6. Nakada Subdivision 2023 Replat

KPB File 2023-123

**ITEM #6 - PRELIMINARY PLAT
Nakada Subdivision 2023 Replat**

KPB File No.	2023-123
Plat Committee Meeting:	December 11, 2023
Applicant / Owner:	Charles & Laura Kelly of Homer Alaska
Surveyor:	Stephen Smith / Geovera, LLC
General Location:	Heather Street in Kachemak APC

VICINITY MAP
SCALE: 1" = 1 MILE U.S.G.S. QUAD. SELDQVA (C-5)

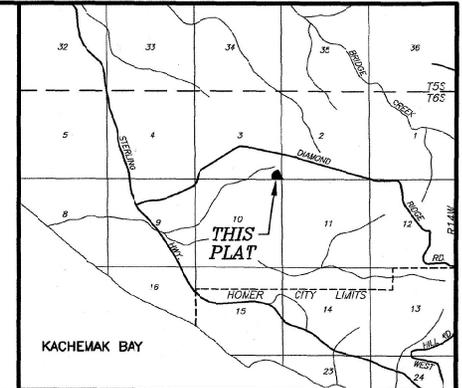
- D. A vicinity map, drawn to scale showing location of proposed subdivision, north arrow if different from plat orientation, township and range, section lines, roads, political boundaries, and prominent natural and manmade features, such as shorelines or streams;
Staff recommendation:
Move subdivision block east to be in both sections.
Label the rivers and creeks on the map.
Show and label Heather Street

NAKADA SUBDIVISION 2023 REPLAT

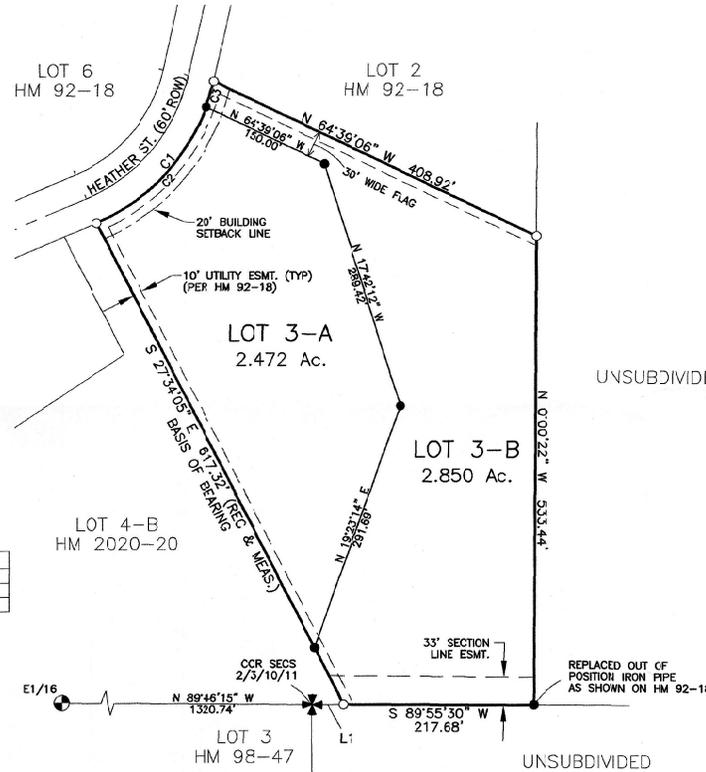
Staff notes that both houses are accessing Heather Street from one drive and access point. If a change of ownership for either lot occurs and access agreement should be drawn up if this is to remain as the means of access to the structure on Lot 3-B and not the flag pole entrance lane.

Road access for lot 3-B places the driveway is very close proximity to lot 2 to the north. No department objection, just an issue that may require some conditions through driveway permitting.
SOA DOT comments

Nakada Subdivision granted the 10’ front utility easement at the right of way along with 10’ side utility easements on interior lot lines. **Staff recommends:** the Commission concur that the 10’ utility easements on the interior lot lines does not need to be carried forward to this subdivision interior lot lines.

Nakada Subdivision HRD 92-18 granted a 10’ utility easement along the front right-of-way and sidelines of the lots and they are shown on the drawing. **Staff recommends:** the note flagging the easement in as (typ) be moved as the arrow is intersecting with the lot line to the west.

There is an easement to HEA in Book 309 Page 737. **Staff recommends:** the surveyor flag this easement in with a reference to corresponding plat note.

Easement in Book 9 Page 99 to Home Electric Association need to be added to Plat notes.

Add 2023-123 to KPB File No.
Lot 4-A to the west need labeled.

- *Plat note 4 should be separated for the two easements listed, the front 10-foot utility easement and the utility easement along the northerly line with a book and page.*
- *Add to Plat note #6, the code at the end of the sentence as shown, "The borough will not enforce private covenants, easements, or deed restrictions per KPB 20.60.170."*
- *Plat note #8 can be removed as there are no wetlands on or near the property.*
- *Plat note needs added for easement in book 9 page 99at CTP #7*

Add the date of December 11, 2023 to the Plat Approval
